LINDEN VILLAGE

Assisted Living Community

Early Design Guidance Meeting #2

DPD Project #3020289

EDG -1-MASSING COMMENTS

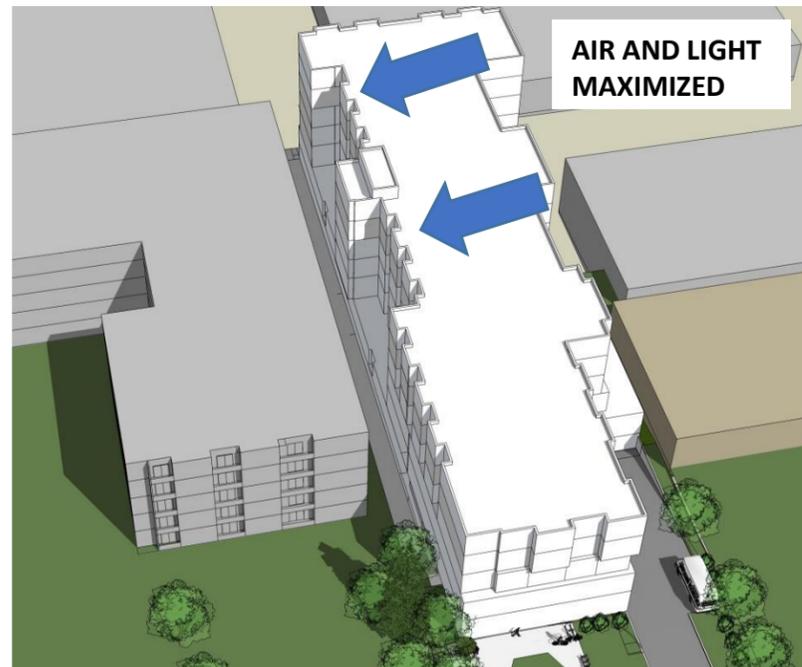
- 1. (a) Maximize light and air to the greatest number of units, including to the adjacent properties. **(CS1-B-1, CS1-B-2, DC2-A-1)**
- 1. (d) Minimize Potential Privacy Conflicts

- The building is shifted south for all five upper floors in locations shown to allow approximately equal distance to both north and south property lines.
- Maximized light and air to north and south buildings.
- Minimized potential privacy conflicts by maximizing distance to property lines.
- The building was narrowed to increase light and air and was lengthened by extended toward Linden Avenue to embrace the Linden Village Neighborhood Plan to locate building front at property line.

STREET / BUILDING RELATIONSHIP AND PARKING

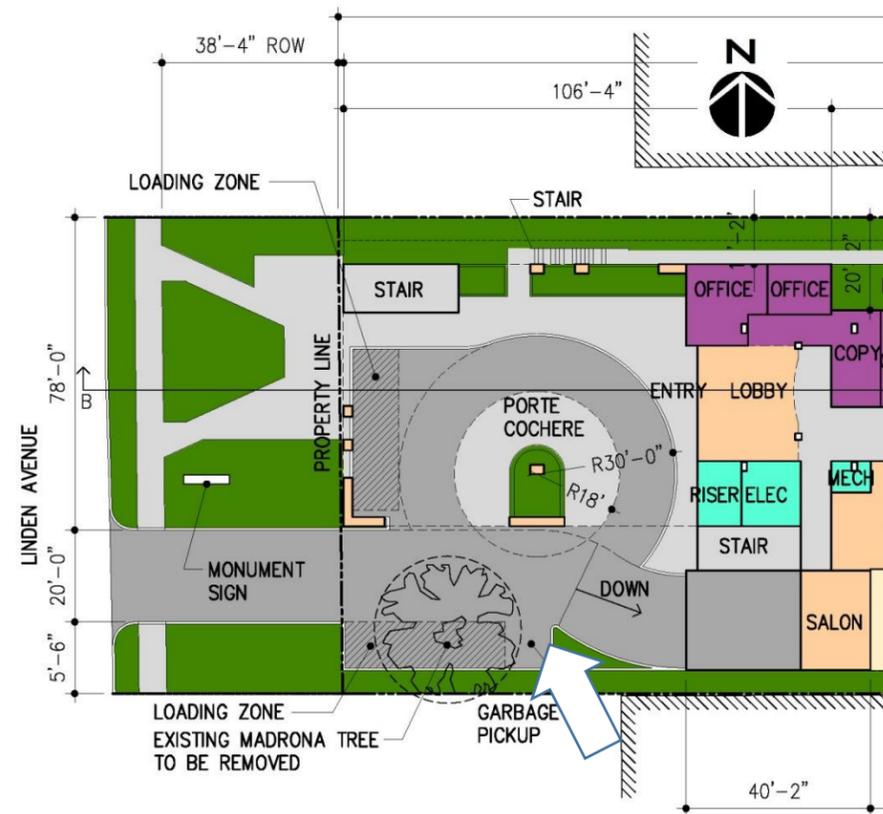
2. The Board was concerned with the surface parking separation between the proposed use and the outdoor amenity space located in the front setback and did not feel strongly that a setback was justified based on the existing context. However, the Board did note that a drop-off and short term parking for this type of use (assisted living facility) was logical.

- a. The Board noted that the primary entry to the site should be easily identifiable and significant. The primary entry should be integrated into the larger architectural concept and secondary architectural features and materials should be used to further emphasize the entry. **(PL3-A-1, PL3-A-2, PL3-A-4).**

- b. Accessibility and the pedestrian experience should be a priority. If parking is to be located between the entry and the front setback amenity space, a direct pedestrian-oriented path between the sidewalk, front setback amenity space and building/primary entry, should be included. **(PL4-A-1, PL4-A-2, DC1-B- 1, PL2-A-1, PL2-A-2).**

- c. For the next meeting, the applicant should demonstrate alternative options for resident pick- up/drop-off and short term parking that would not require surface parking in the front setback. The Board noted that the design needs to create a strong relationship between the building, the outdoor amenity space, and street, while minimizing the negative impacts of the vehicle drop off, emergency vehicle access, and surface parking (if included). This design may include drop-off adjacent to the driveway/entry with vehicle turnaround and short-term parking internal to the site, a porte cochère drop-off with uses such as outdoor amenity space above, a woonerf treatment of the surface parking lot, pedestrian oriented details such as high quality surface treatment, a raised “cross-walk”, roundabout, and/or landscaped bulb-outs. **(CS2-B-2, CS2-B-3, PL1-C-1, PL4-A-1, DC1-B-1).**

- Parking that was proposed at the front of the building in EDG-1 is not removed. All parking is now in the garage below grade.
- The building front wall was moved 75 feet forward to be located at the property line.
- The proposed design now provides an easily identifiable and significant entry and is integrated into the larger architectural concept
- Design emphasizes accessibility and the pedestrian experience.
- Short term drop-off internal to the site and is out of sight.
- Promotes a mixed use look and feel.
- Promotes interaction between residents, pedestrians and bicyclists.
- Promotes merging and smooth transition between indoor/outdoor spaces.

LANDSCAPE PLAN –FULL SITE

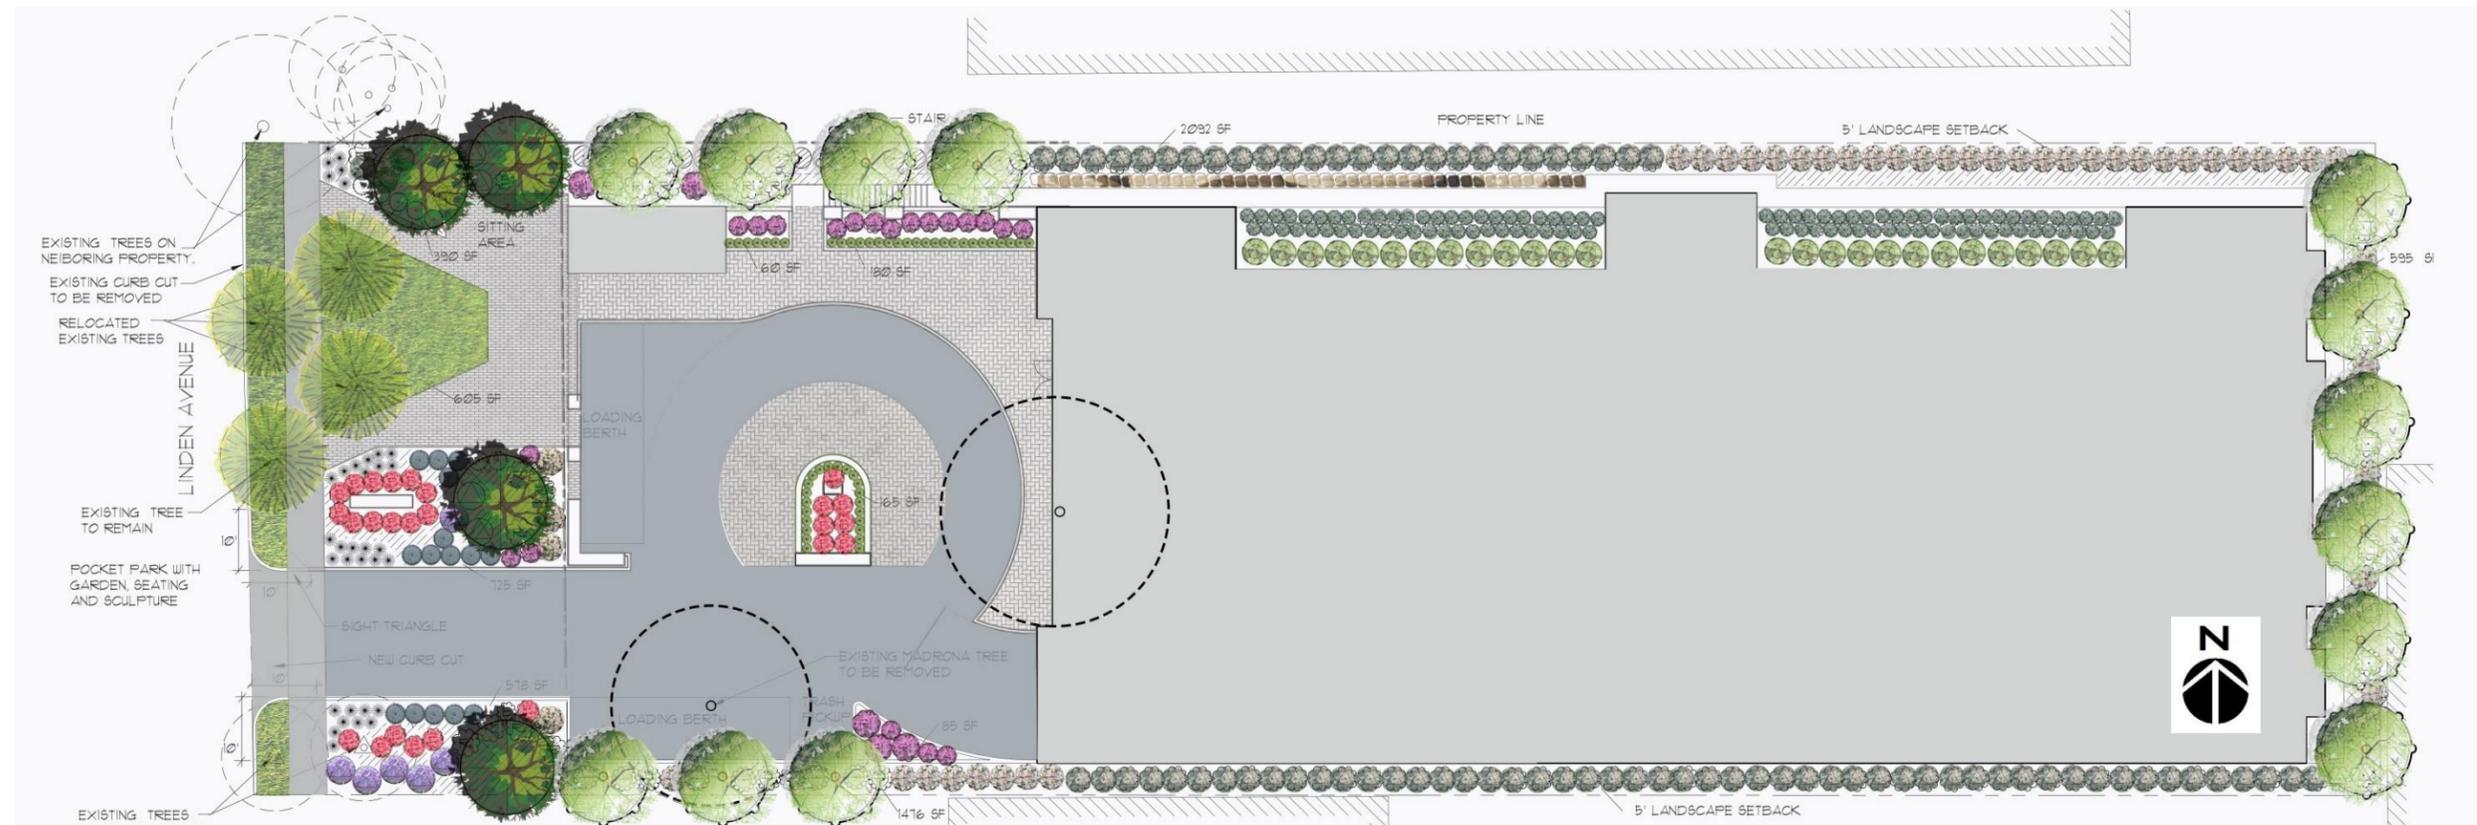
- d. For the next meeting the applicant should include cross-sections showing the right-of-way, front-yard setback/amenity space, surface parking (if included), entry, and building. Additionally, the applicant should include a conceptual landscape plan.

Existing street trees along Linden Avenue N will remain or be relocated along the street, and will unify the site with the neighborhood. There will be a large landscaped area between the sidewalk and the drop-off area with lawn, benches, and dense screening of the parking area. There will be an accessible walk connecting Linden Avenue N to the building entry.

The Northern and Southern edges will be screened with evergreen hedges that will reach a mature height of 6'. The western edge will be landscaped with a mixture of columnar trees and evergreen shrubs. The plant material will provide a variety of colors, textures, and heights, with a mixture of evergreen and deciduous plants, with the intent to soften and enhance the building and provide a positive, attractive addition to the neighborhood.
